Illinois Department of Transportation

SUBJECT: Aurora Municipal Airport
Aurora, Illinois
Kane County
Illinois Project Number: ARR-5201
SBG Project Number: 3-17-SBGP-TBD
Contract No. AU075
Item No. 06A, November 7, 2025 Letting
Addendum A

NOTICE TO PROSPECTIVE BIDDERS

REPLACE AIRFIELD
SIGNAGE, WIND CONES,
RUNWAY 15 AND 27
RUNWAY END
IDENTIFIER LIGHTS,
AND AIRPORT
ROTATING BEACON

SITE PLAN AND PROJECT CONTROL PLAN SUMMARY OF QUANTITIES

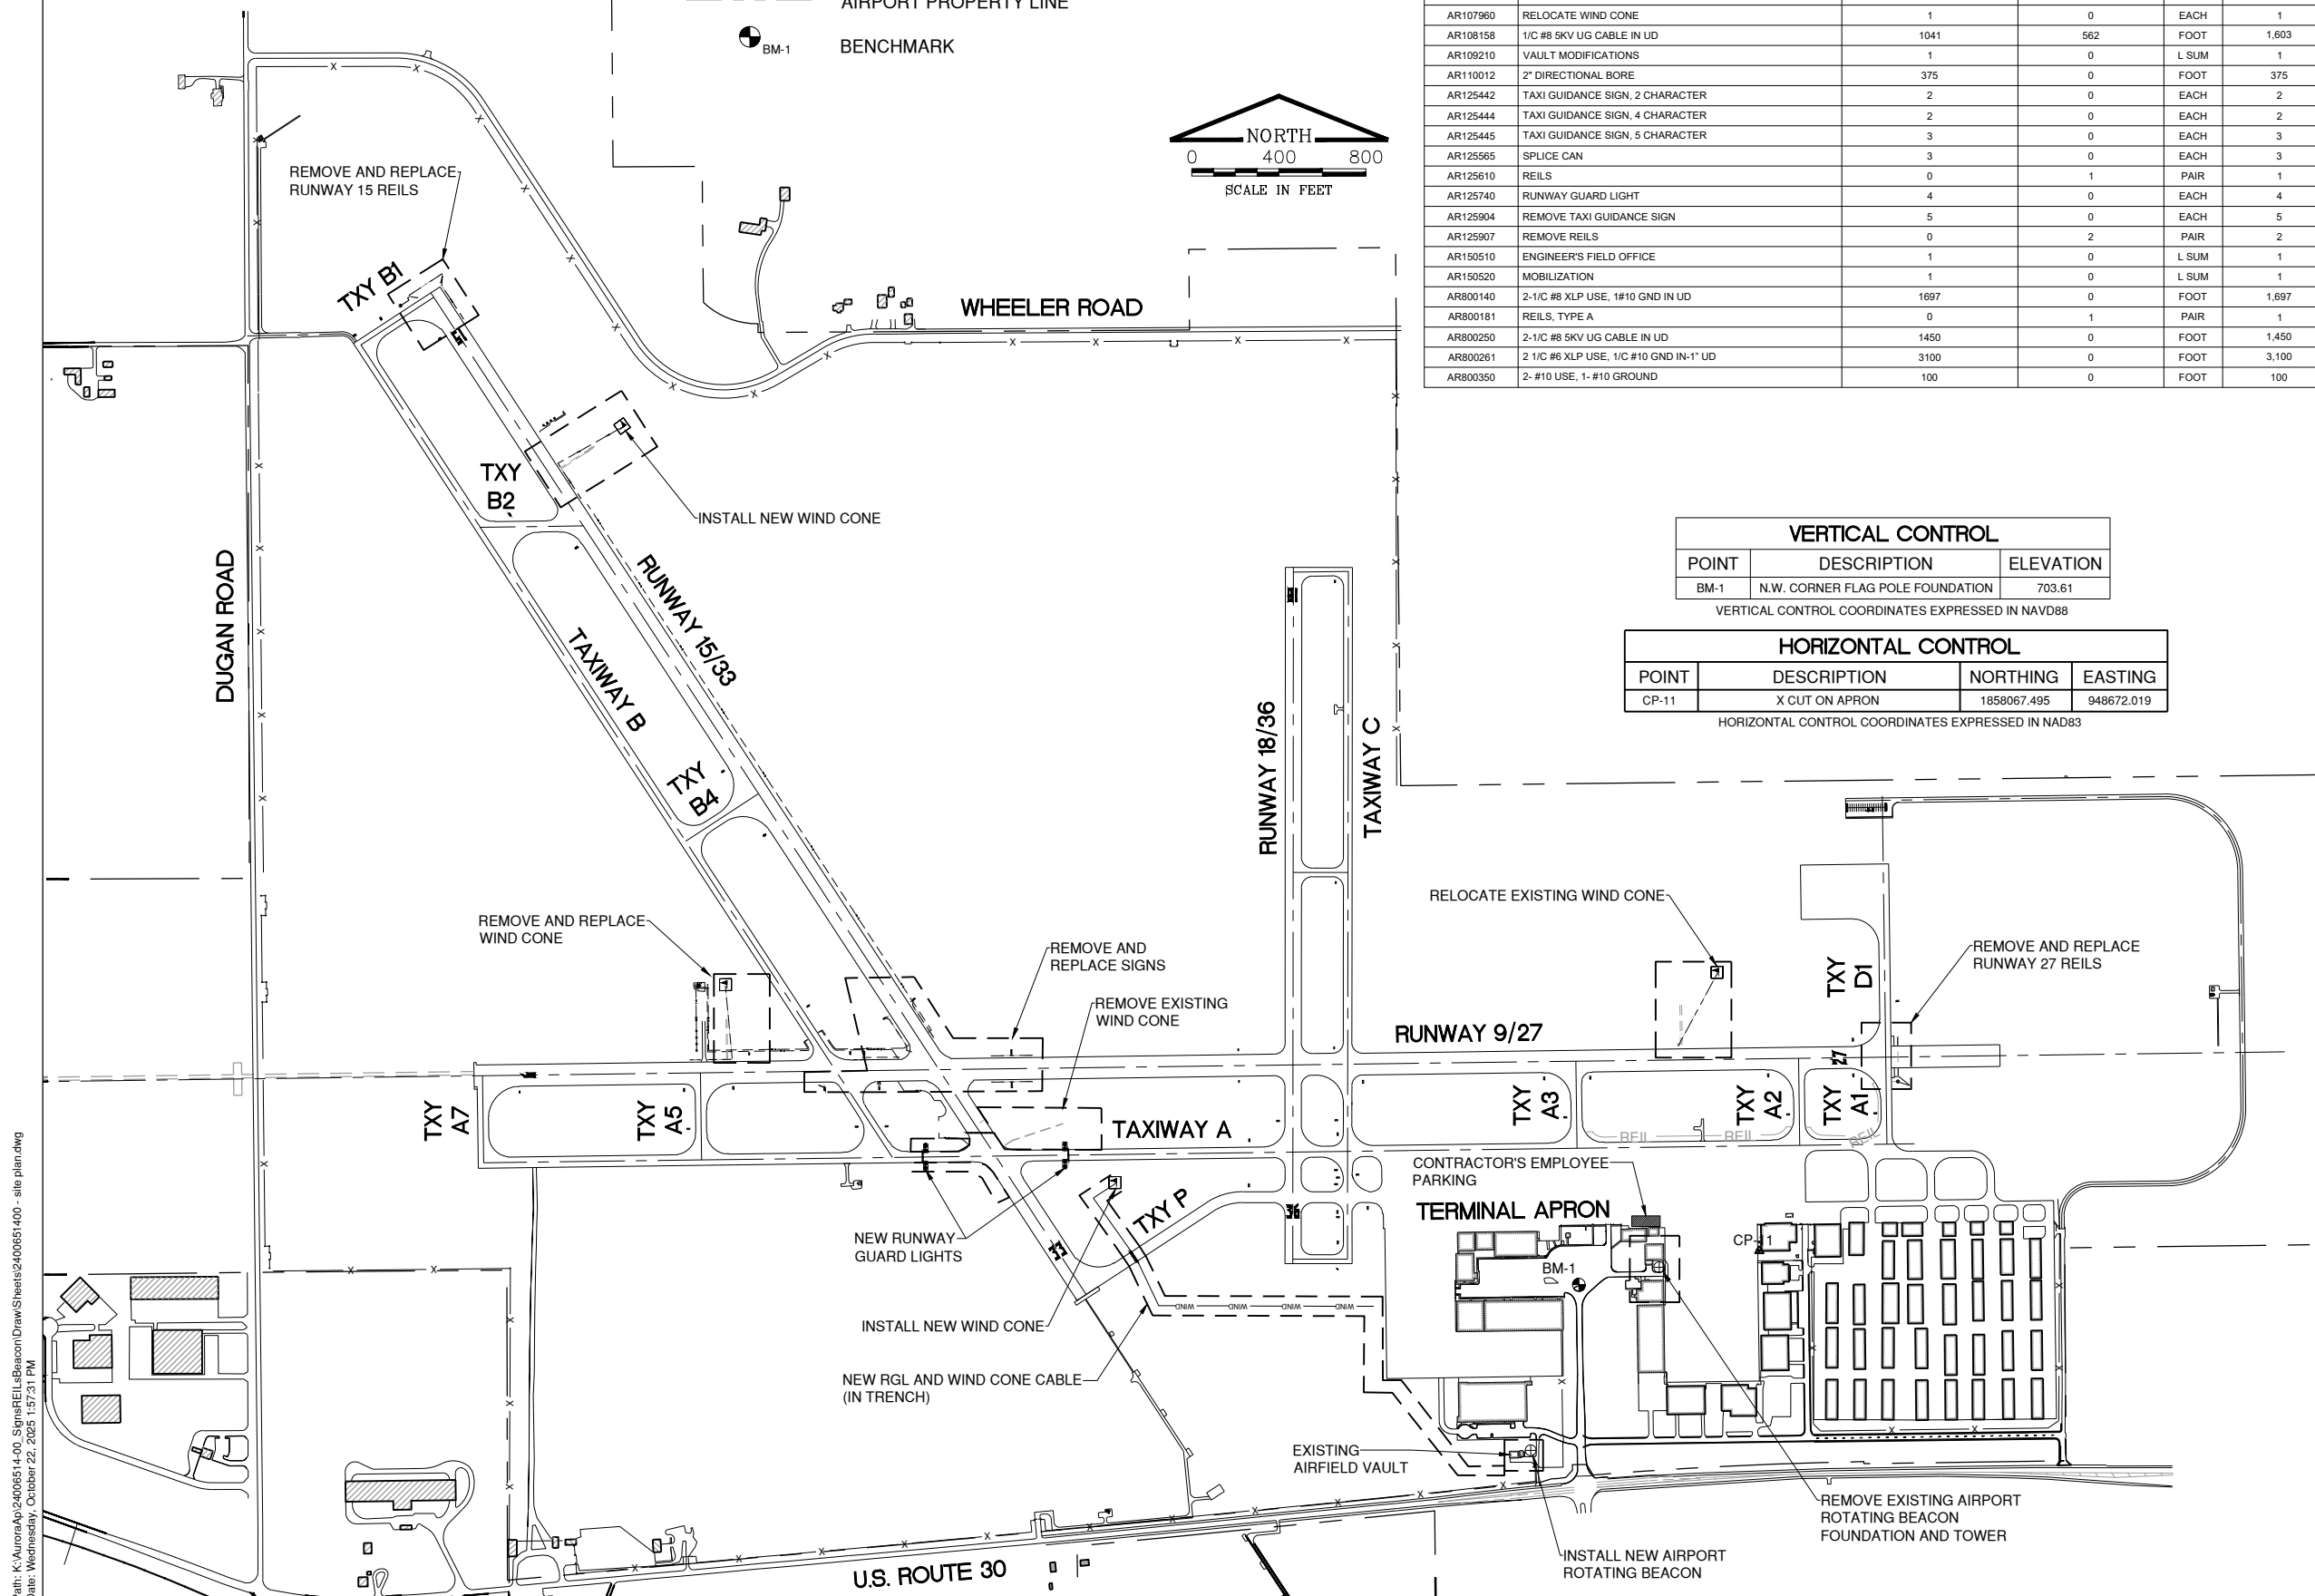
1. Sheet 2 – Site Plan and Project Control Plan/Summary of Quantities
 - a. Summary of Quantities table – Revise AR107812 L-807 W C-12' Internally Lit to 1 Each.

10/22/25 REVISE TABLE

SEQUENCE OF
CONSTRUCTION - 2

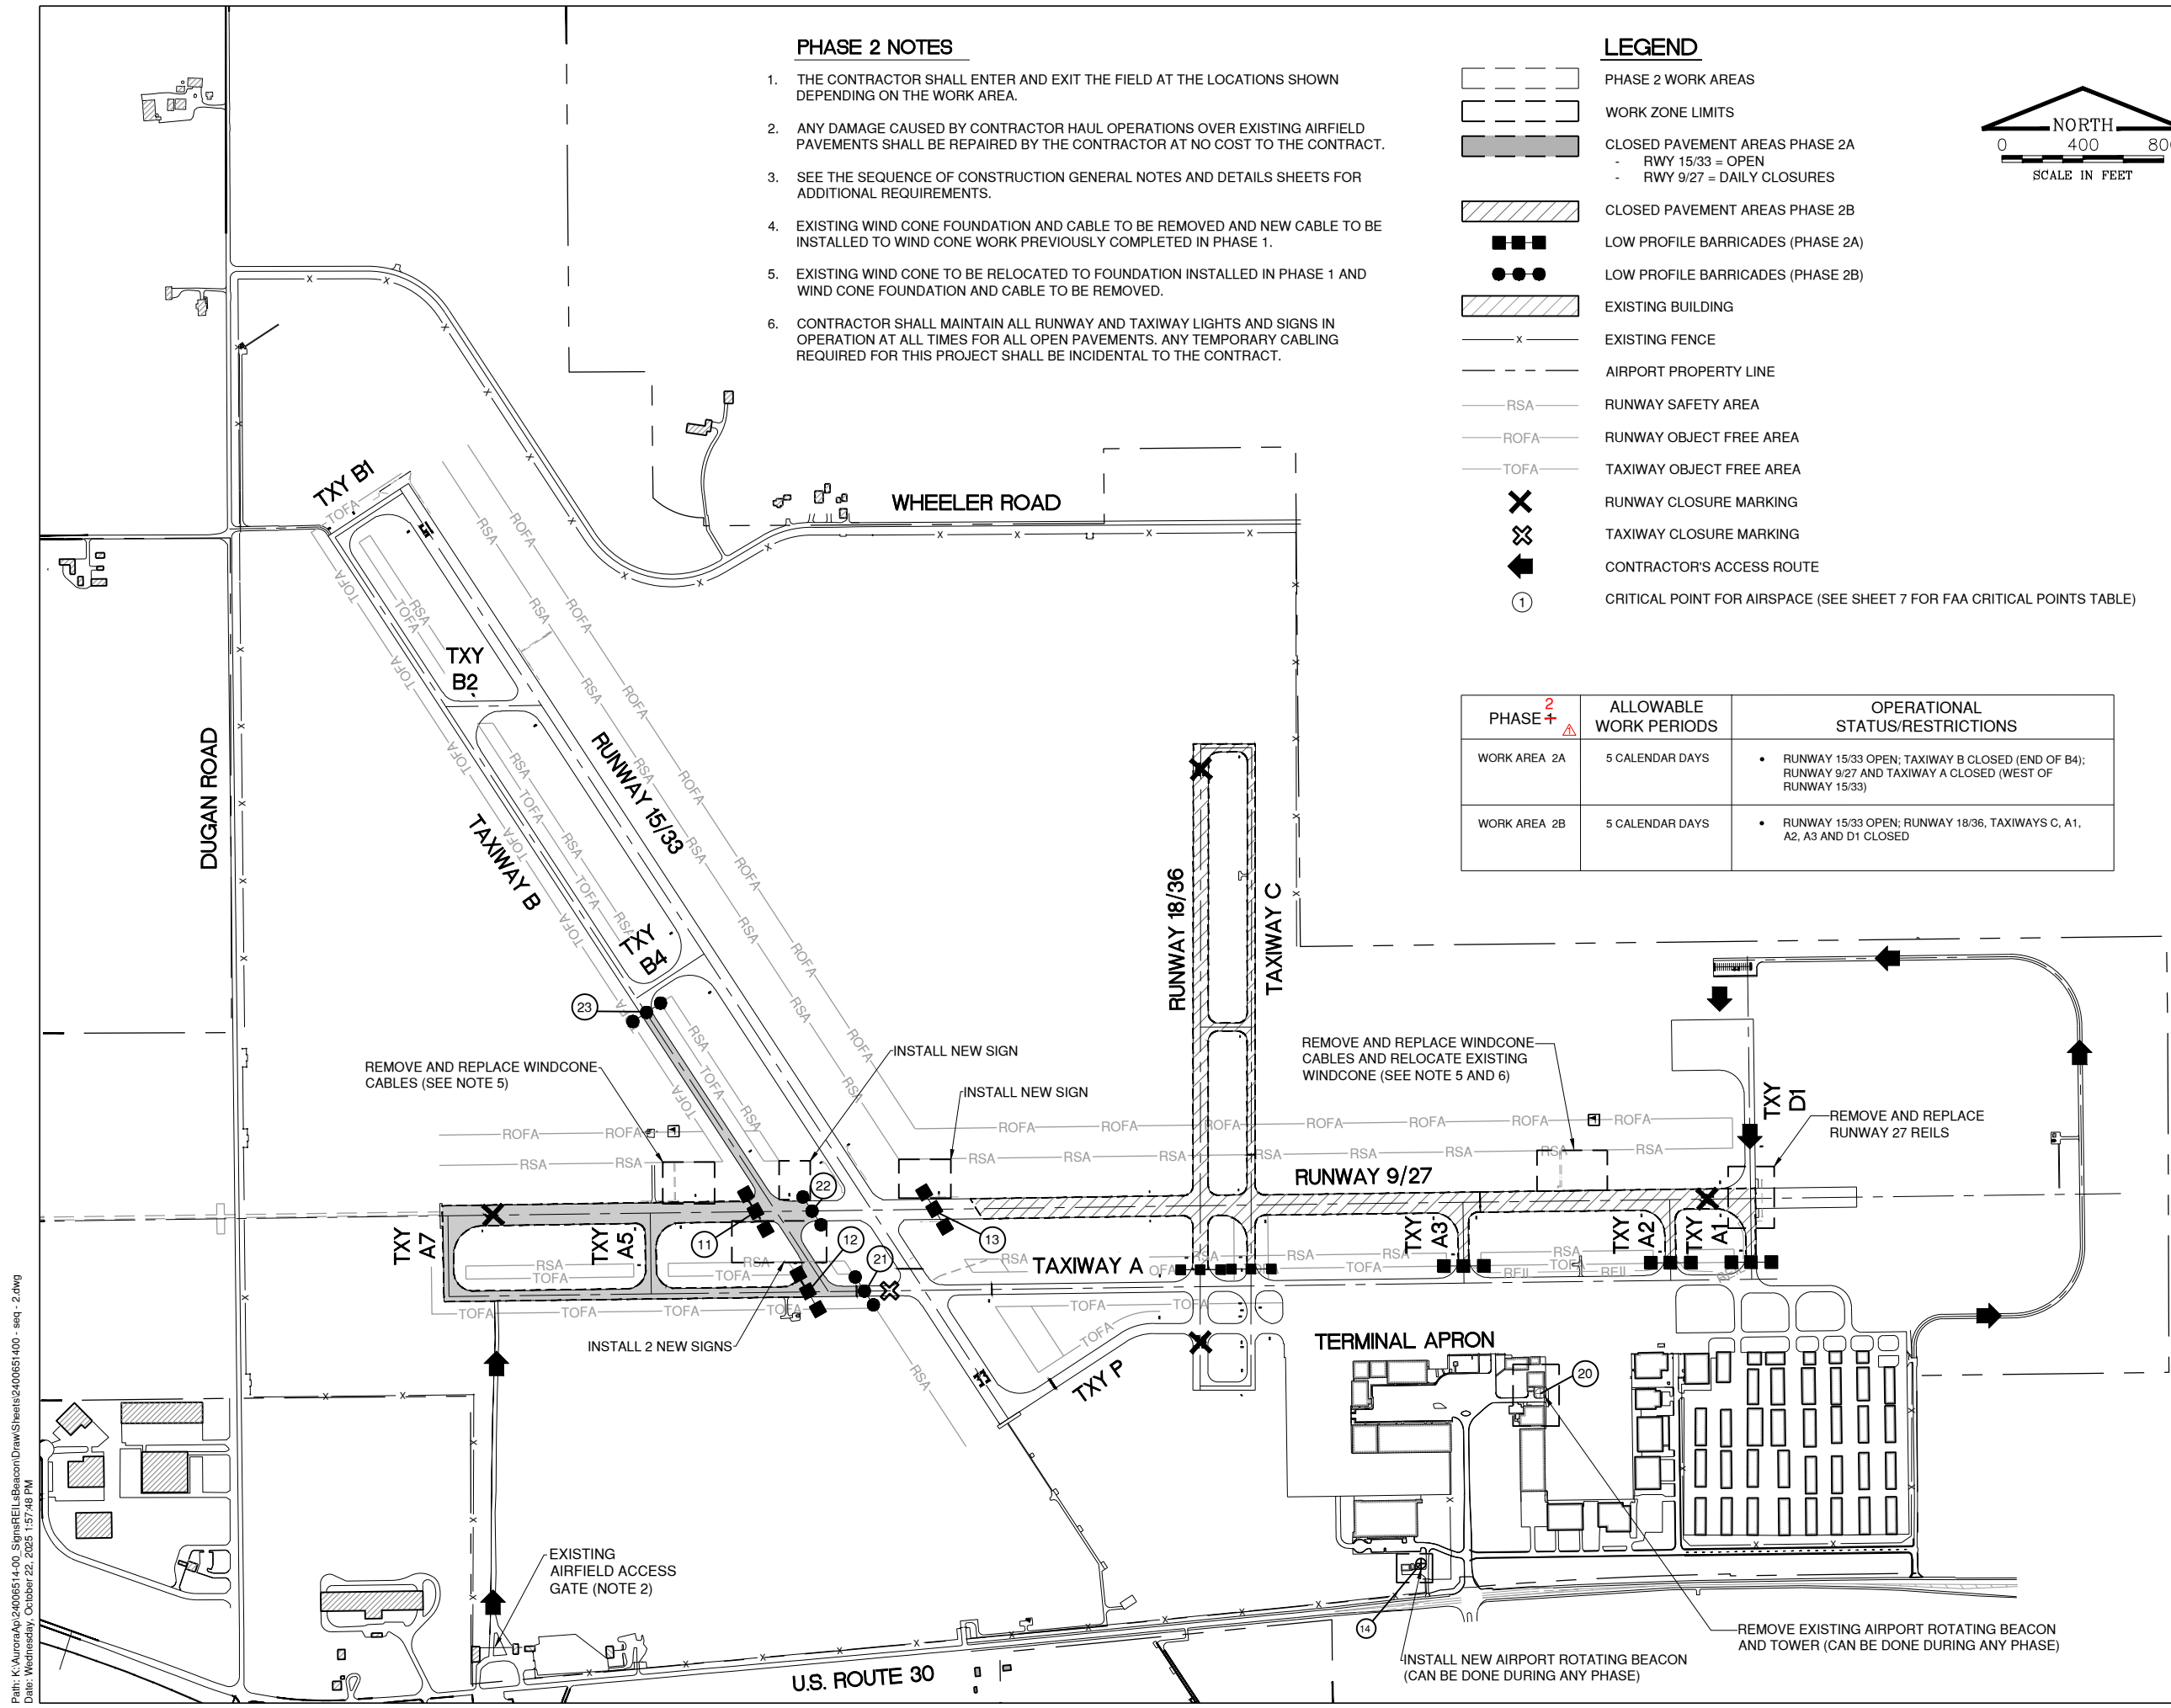
2. Sheet 4 – Sequence of Construction – 2
 - a. Revise table to reference Phase 2.
3. Sheet 5 – Sequence of Construction – 3
 - a. Revise table to reference Phase 3.

10/22/25 REVISE CALENDAR DAYS
REVISE TABLE

SEQUENCE OF
CONSTRUCTION - 3

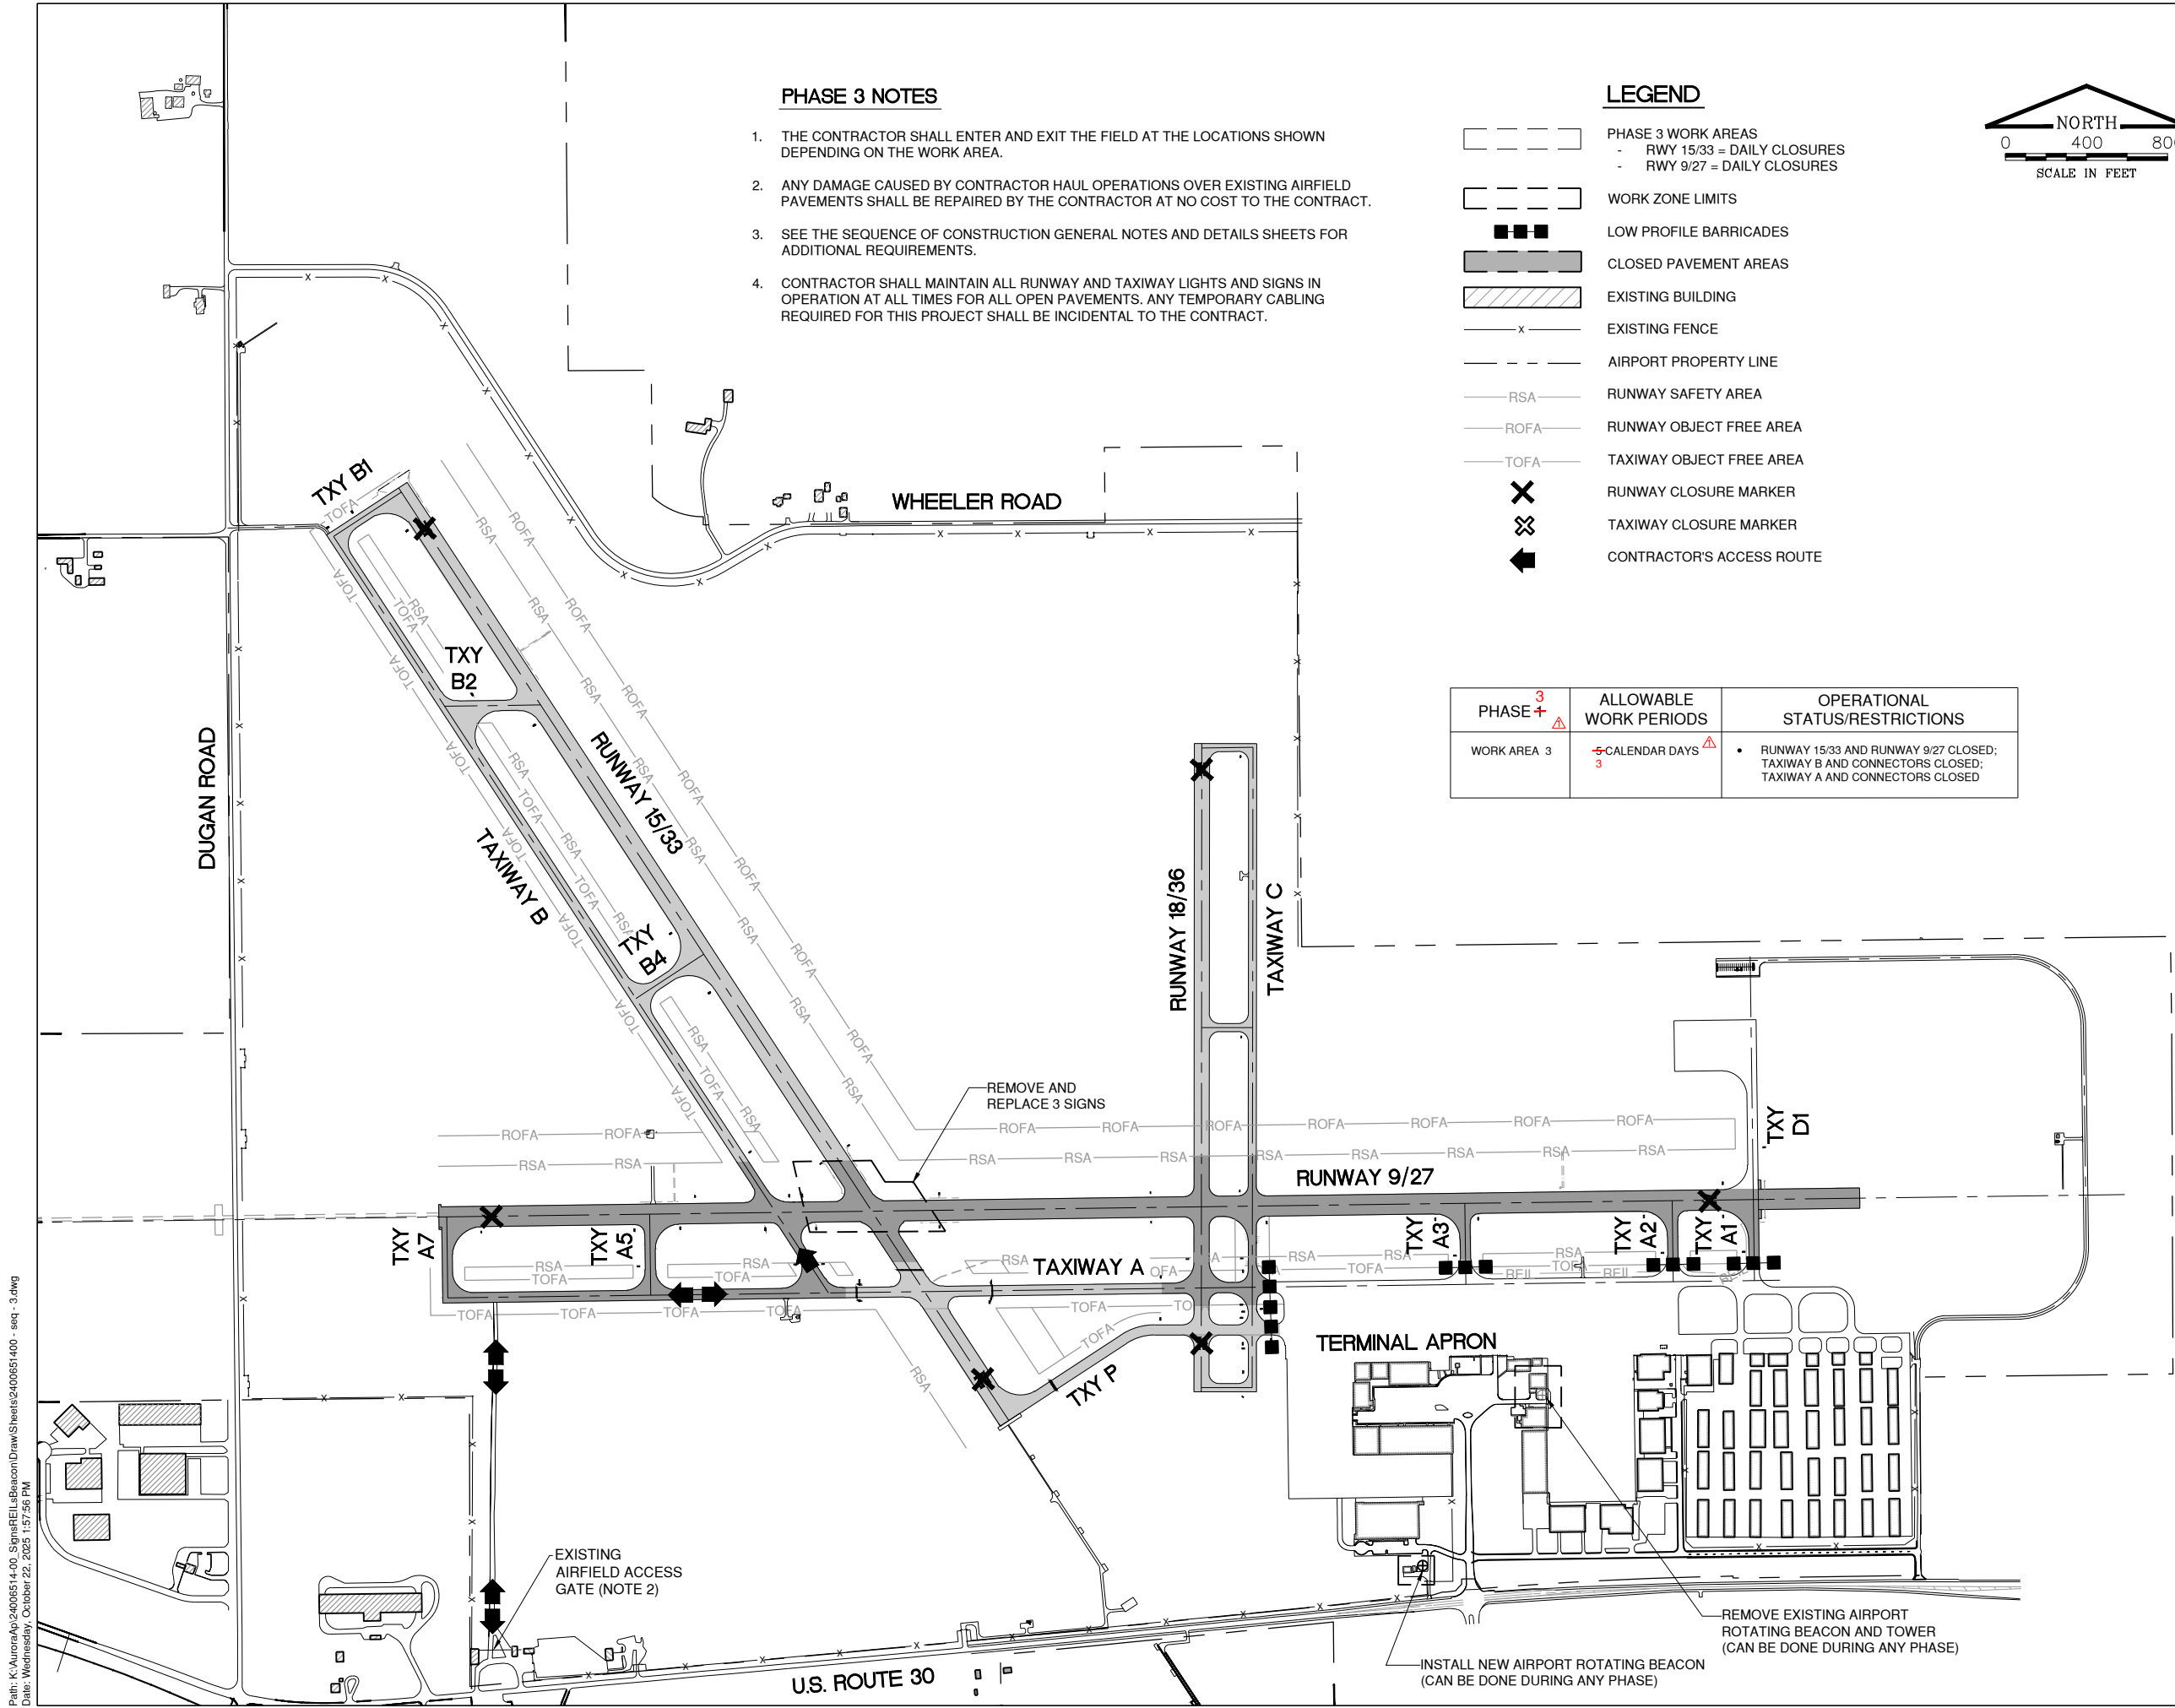
- b. Revise allowable work periods for Work Area 3 to three (3) calendar days.
4. Sheet 6 – Sequence of Construction Notes
 - a. Revise total contract time to 35 calendar days.

PHASE 3	ALLOWABLE WORK PERIODS	OPERATIONAL STATUS/RESTRICTIONS
WORK AREA 3	5 CALENDAR DAYS	- RUNWAY 15/33 AND RUNWAY 9/27 CLOSED; - TAXIWAY B AND CONNECTORS CLOSED; - TAXIWAY A AND CONNECTORS CLOSED
